A G E N D A
FARRAGUT MUNICIPAL PLANNING COMMISSION

December 17, 2015
7:00 p.m. Farragut Town Hall

**SUBJECT: STAFF COMMENTS ON A SITE PLAN FOR FAÇADE MODIFICATIONS AT
SUMMIT VIEW OF FARARGUT, 12823 KINGSTON PIKE**

SUBJECT: STAFF COMMENTS ON A SITE PLAN FOR A CANOPY ADDITION AT THE SEASONS RESTAURANT AT 11605 PARKSIDE DRIVE

FIRST FLOOR PLAN - PROPOSED

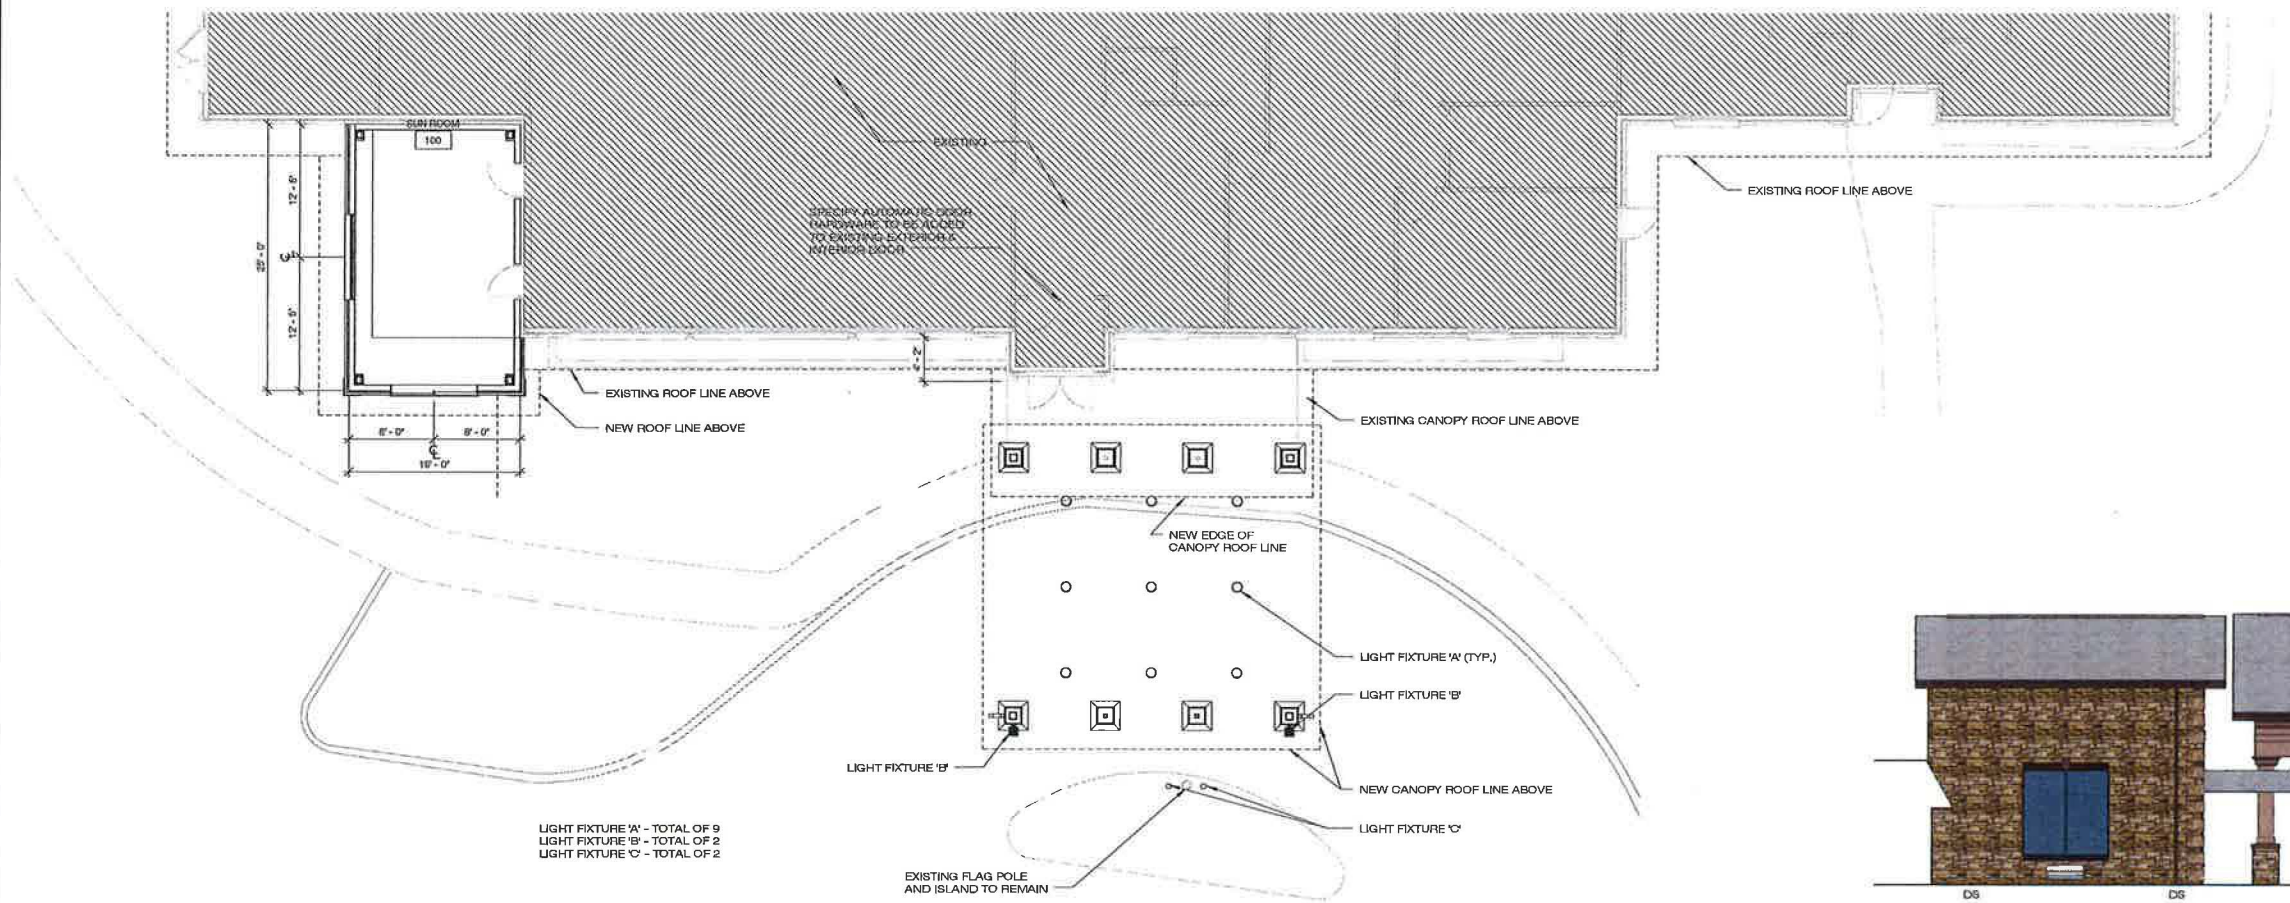
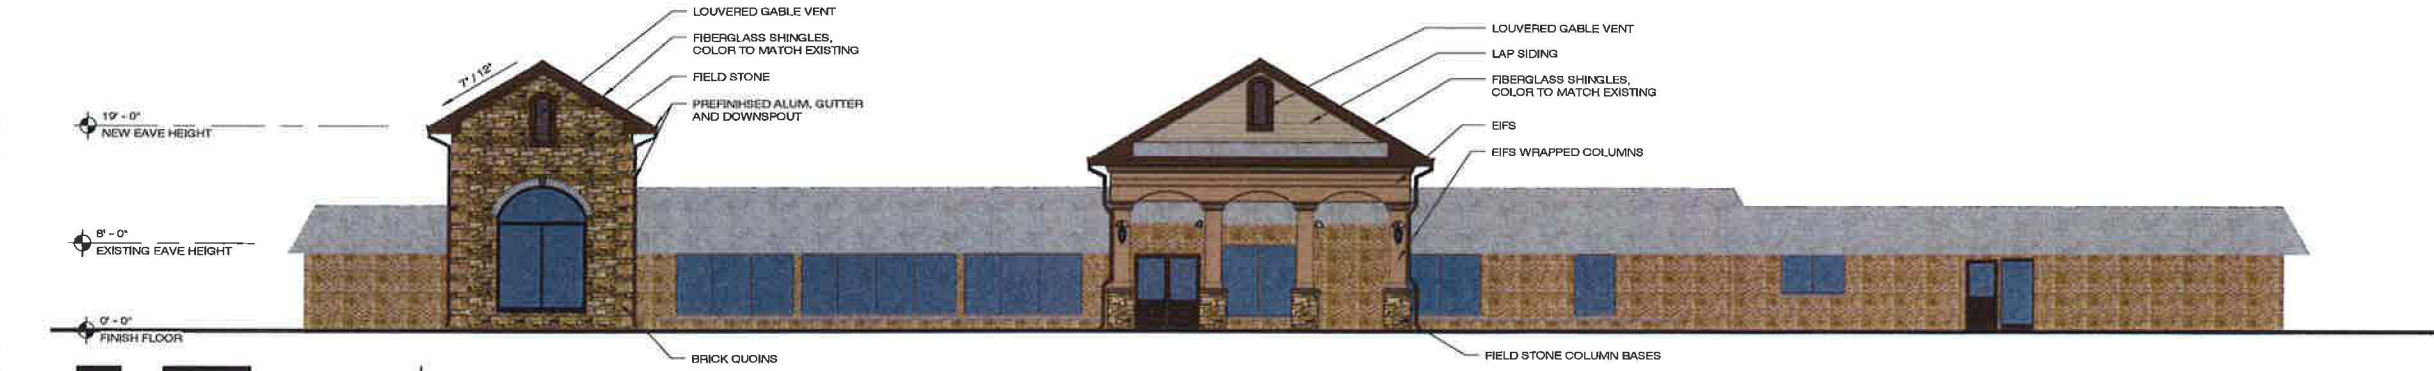
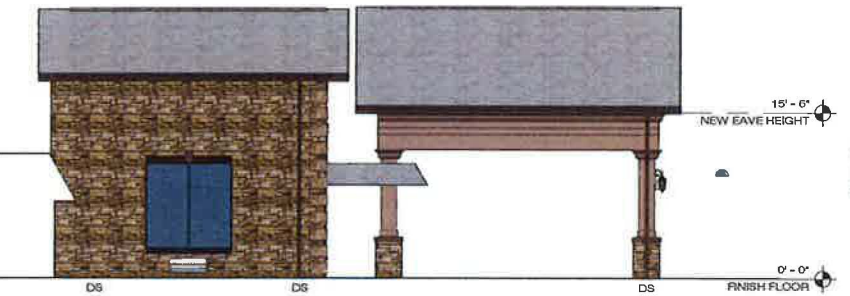
1. Please include (on the plans) the size of the building, the construction type, and the occupancy type;

2. An as-built survey will be required to verify compliance with required setbacks. The front yard setback is 80 feet and the requested canopy addition is shown as 80 feet from the front property line;

3. Please clarify that number of light fixtures proposed and which Fixture A is proposed. It would appear that you are proposing nine (9) Fixture A's, two (2) Fixture B's, and two (2) Fixture C's;

4. Please verify that the light source for Fixtures A and B will be hidden. The light source in Fixture A must be contained in the canopy with the bottom flush with the lower edge of the canopy so that nothing protrudes below the bottom of the canopy. The light source for Fixture B must be contained in the top (black cap) portion of the fixture;

7. Please provide a graphic scale on all sheets;
8. Please sequentially number ALL sheets included in the site plan submittal as 1 of ..., 2 of ..., 3 of ...;

9. Please include updated lot coverage calculations for the site; and
10. Please provide the location of all existing and proposed utilities.

REVISIONS:
DRAWN BY:
DATE: 11/11/15
PROJECT NUMBER: 15043
DRAWING TITLE: PARTIAL SITE PLAN ENLARGED SITE PLAN RENDERING
DRAWING NUMBER: A1

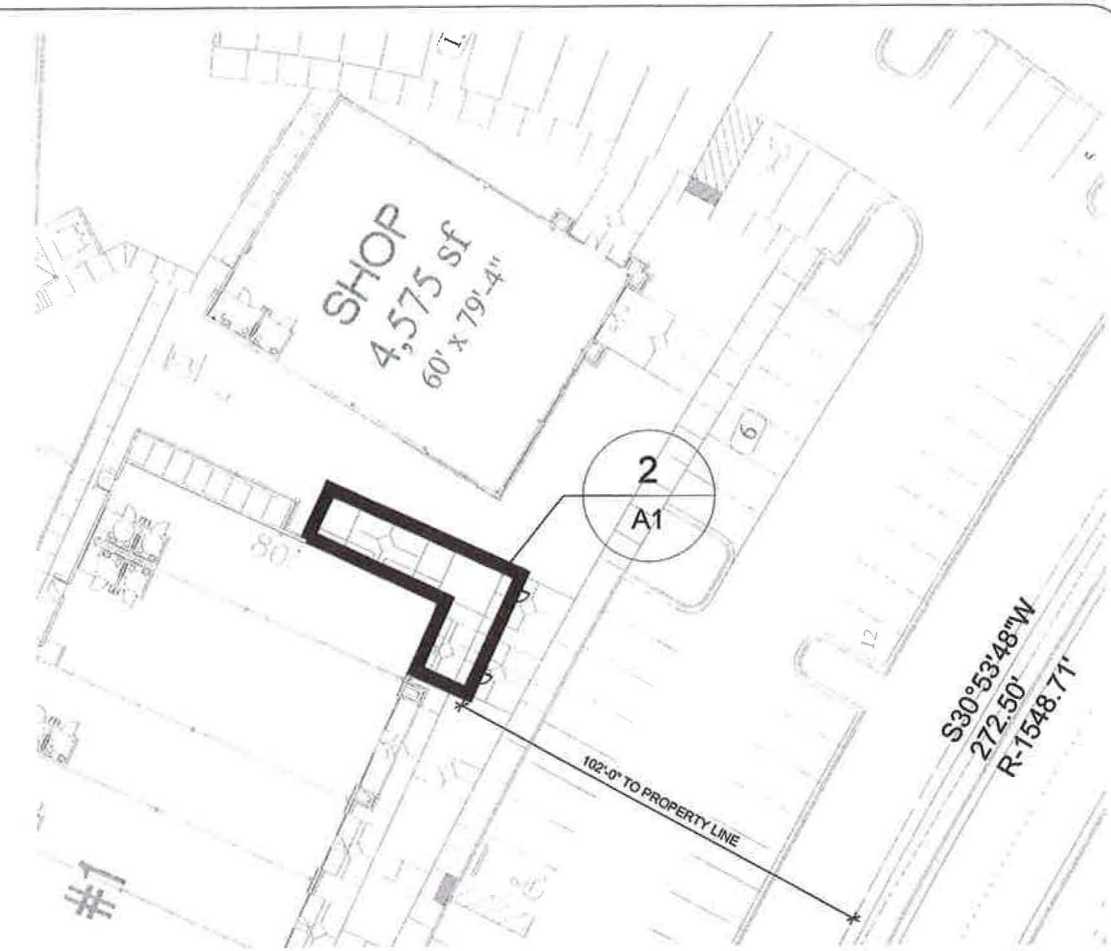
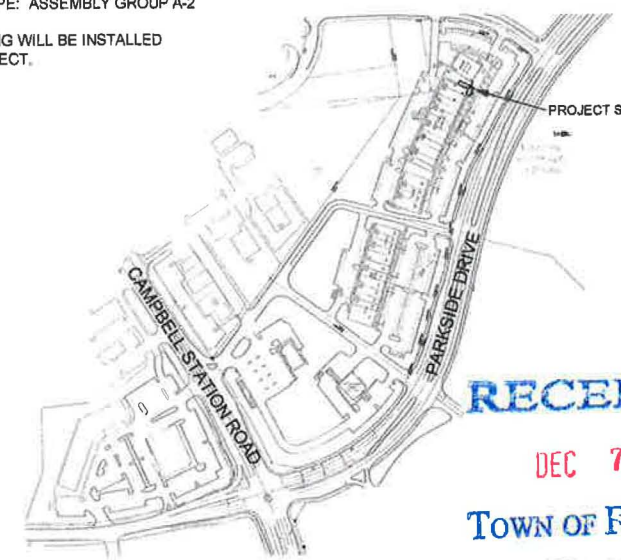
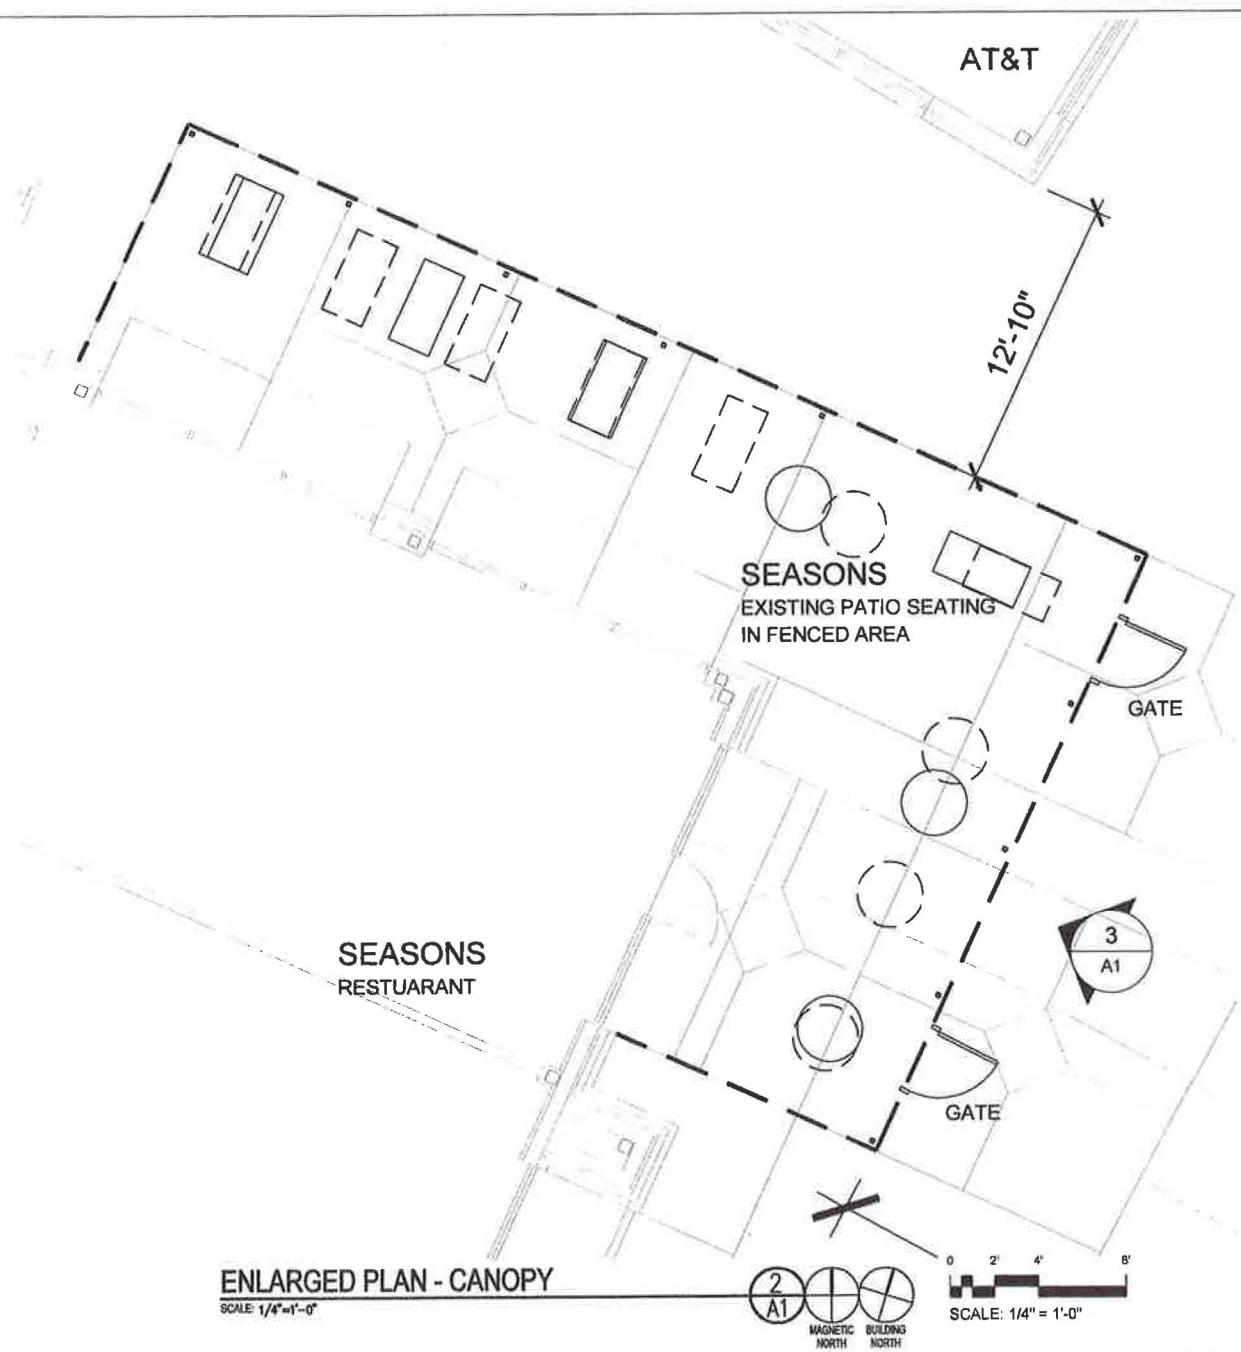
1. No information was provided on the plans to support Type III construction;

1. Please label the property lines and verify that the covered area will meet the front yard setback of 80 feet from the Parkside Drive right of way;
2. Please provide a color rendering or photo simulation of what is proposed and how it would appear as the entire building is viewed from Parkside Drive;

3. Please provide the acreage of the parcel and the dimensions and calls of all property lines;
4. If there is to be additional lighting proposed, please provide a lighting plan and fixture details;

5. Please show all existing and proposed utilities in the proposed improvement area; and
6. The proposed metal roof that is pitched so it is visible from Parkside Drive appears to be in conflict with Standard 2.16 d. of the adopted Architectural Design Standards. This standard states "Do not use fabricated metal panels or vinyl siding;" This is something that the color rendering or photo simulation may better address for the planning commission's consideration of this comment.

Amenity Area - Layout & Dimension Plan

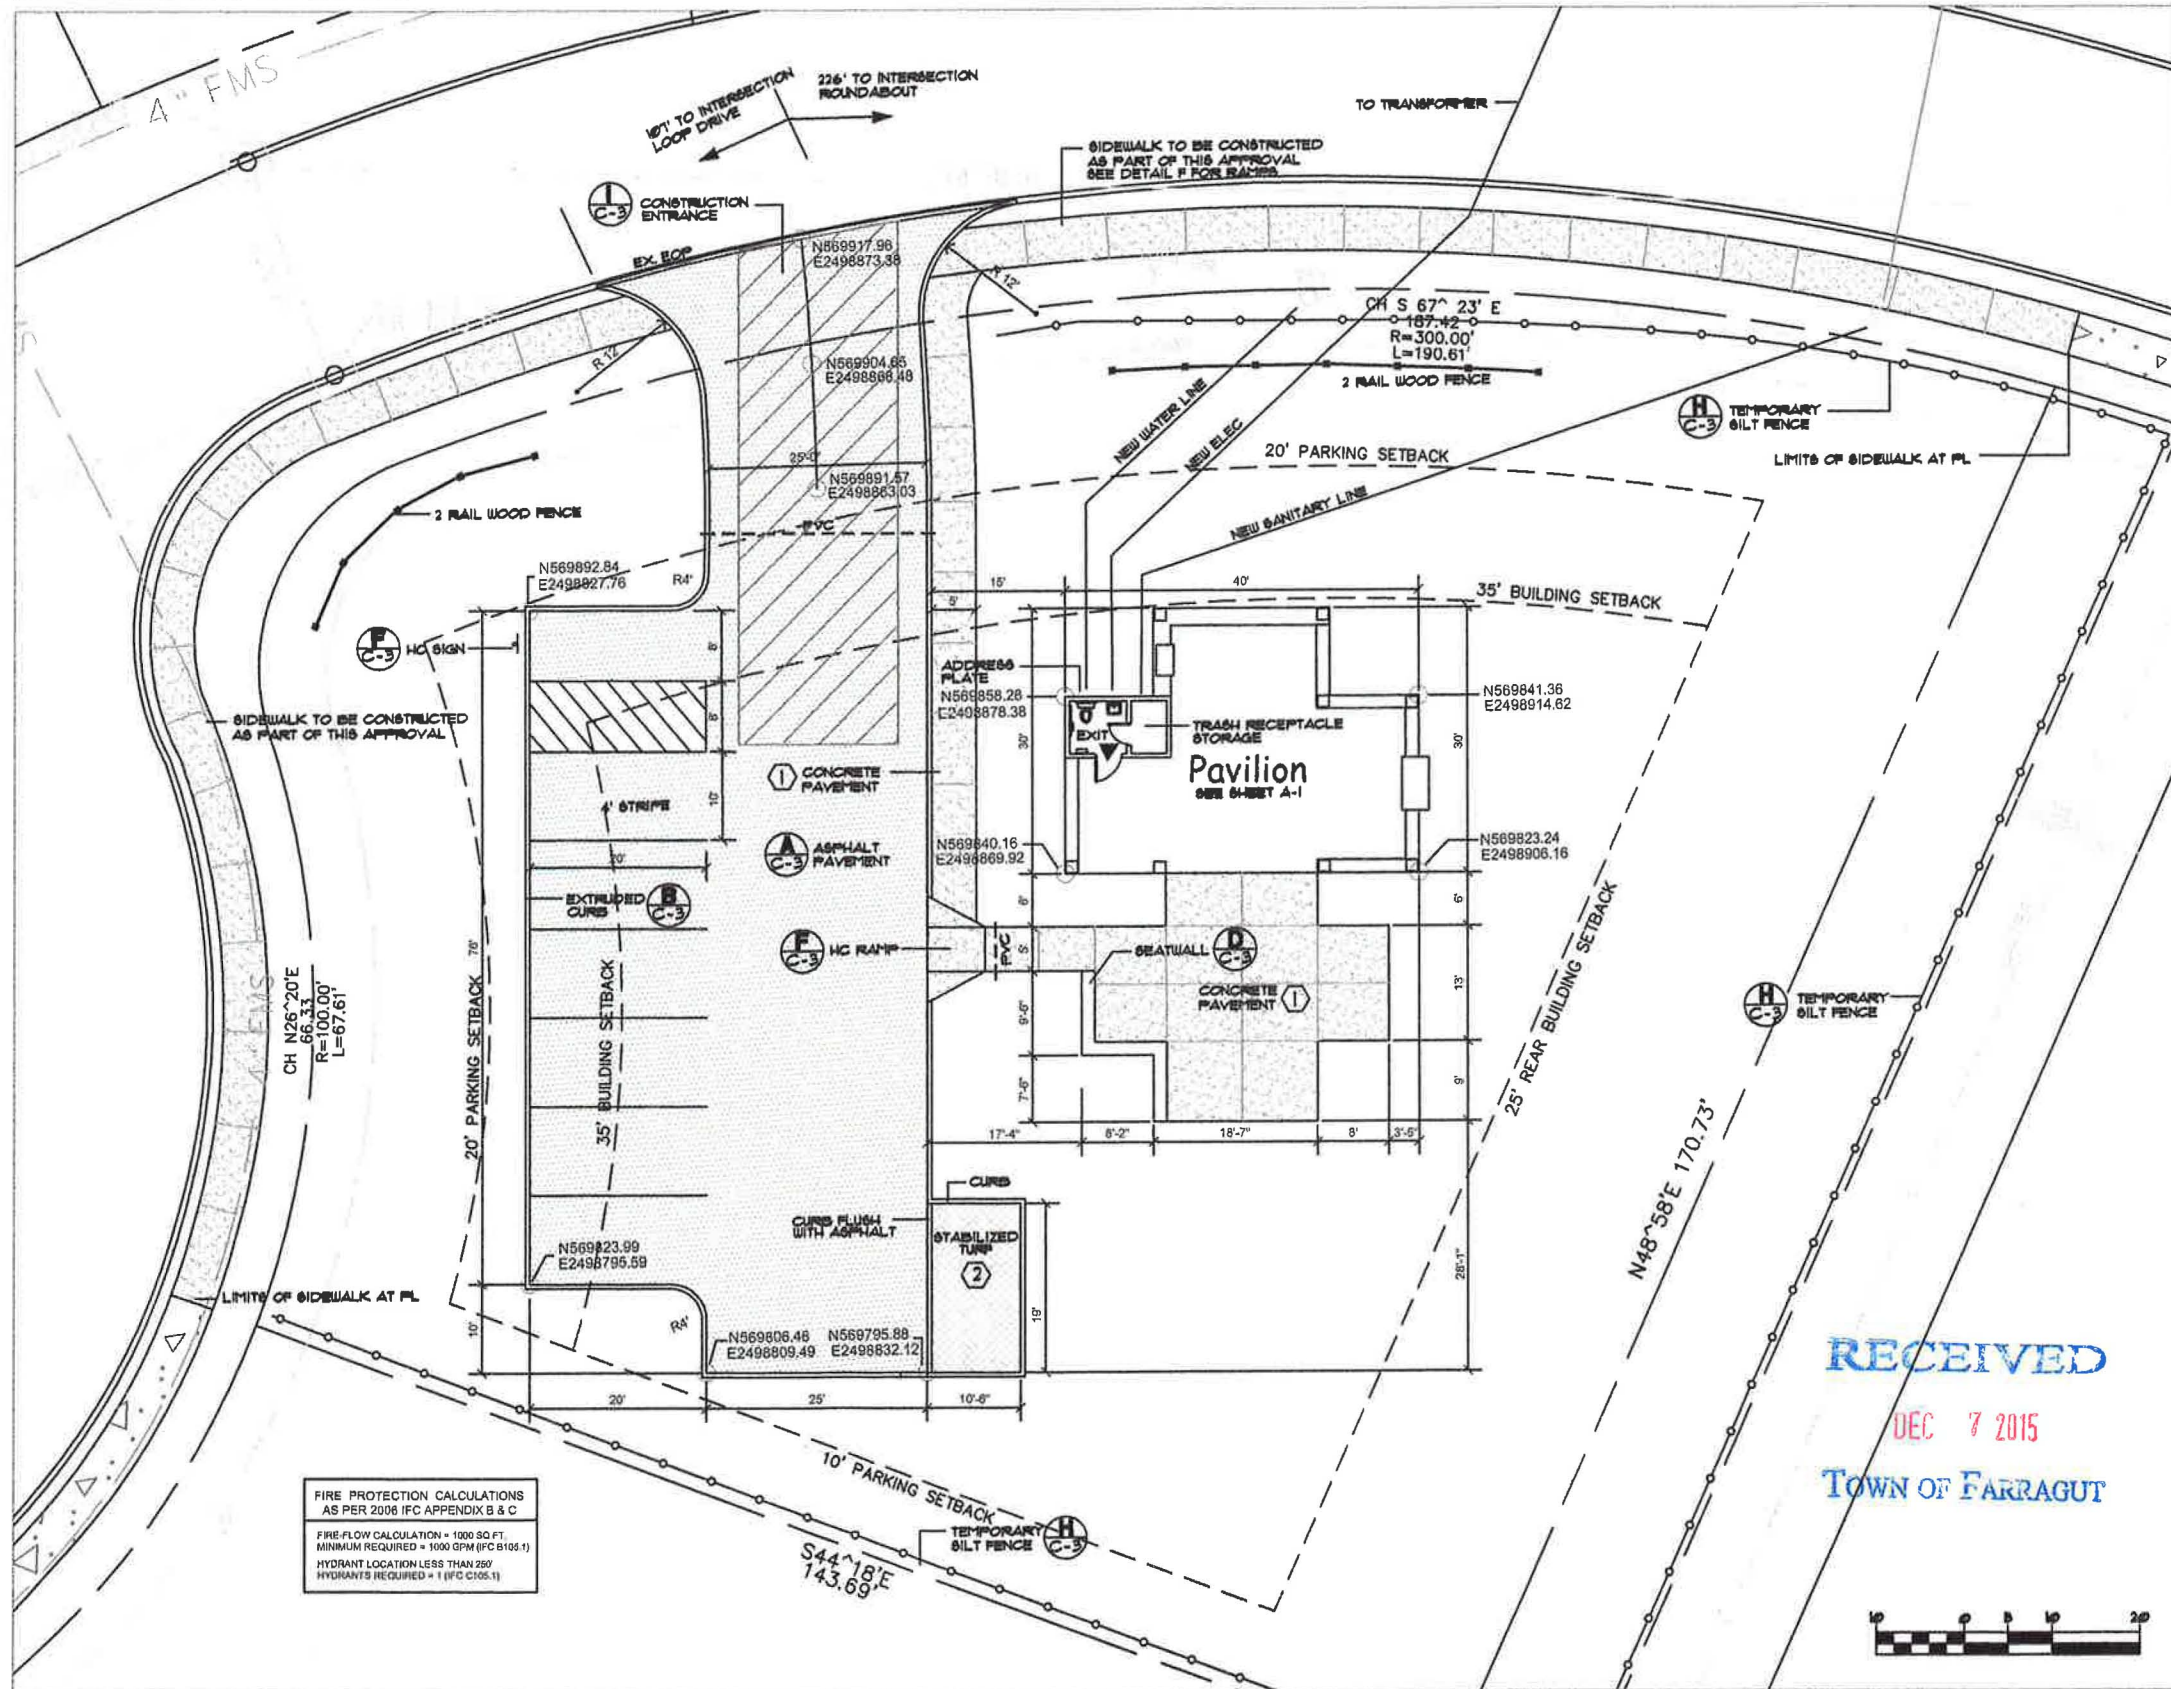
2. Recreational facilities in the OSR are required to meet the development criteria of the base zone (R-1). This would mean that the pavilion will need to be set back 35 feet from the right of way. Please adjust the setbacks and pavilion placement accordingly. There appears to be plenty of room to make this modification;

3. Please include the complete map and parcel information on the cover sheet;
4. Please identify where the addressing will be posted on the pavilion;
5. Please identify the black line near the right of way. Is this a fence?

6. Please provide for a van accessible handicap parking space. You do not need a regular handicap space;
7. Since a dumpster location is not proposed on this site, how will refuse be handled?
